DRAWING AMENDMENTS:

Appendix A

(Figure 7 marked up with proposed changes)

Figure 7

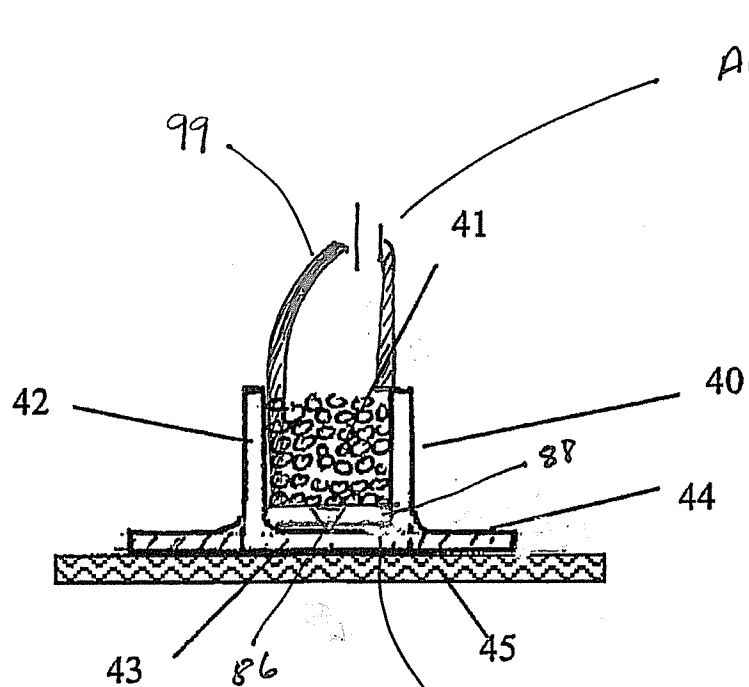
Figure 7 is amended to include the addition of a heater 99, a cutting means 86 retained in housing 88.

The examiner objected to the drawings because they do not show a cutting means or a heater. Amended Figure 7 – which shows the allegedly missing features – are added to the application in the Reply. The specification is amended above to include numeric designations for the amended Figure features. The Figure and specification amendments do not add new matter to the specification.

REMOVE BOTTOM layer of WINDINGS
 ADD HOUSING 88 INCLUDING
 RETAINED SHARPED EDGE 86

Figure 7 is amended to include a heater and cutting means. The specification is amended to add new Figure 7 designations. No new matter is added to the application by these amendments.
